Planning Appeal Online Observation

Case Number / Description
314485

PL06F.314485

Dublin Airport, Co Dublin

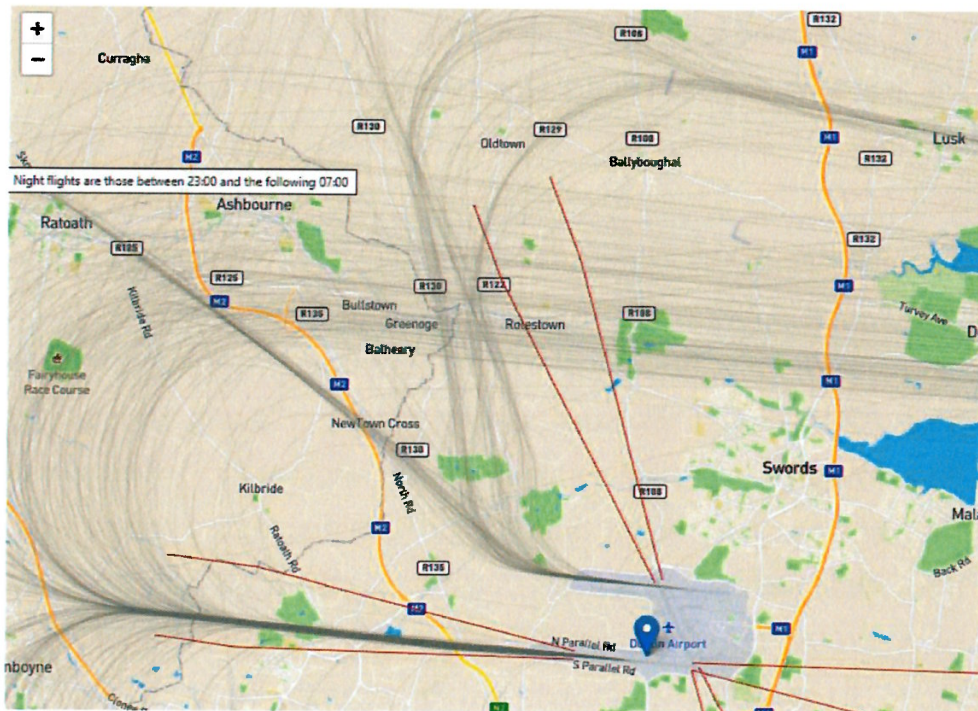
- Flying divergent flight paths on the North Runway for Westerly operations contravening the EIS of 2007
- Divergent flight paths currently in operation do not align with EIAR for this current planning application that is under appeal
- 30-degree divergence was not proposed in the 2016 consultation
- Condition 3 of planning does not allow for dual runway departures under Option 7b
- Flight paths used in Insulation Scheme approved by Fingal County Council in 2016, based on 2007 planning permission, show straight out operations

- Departures on North Runway on August 25-27th and all dates of westerly departures since opening are showing divergent routes contravening the planning permission from 2007
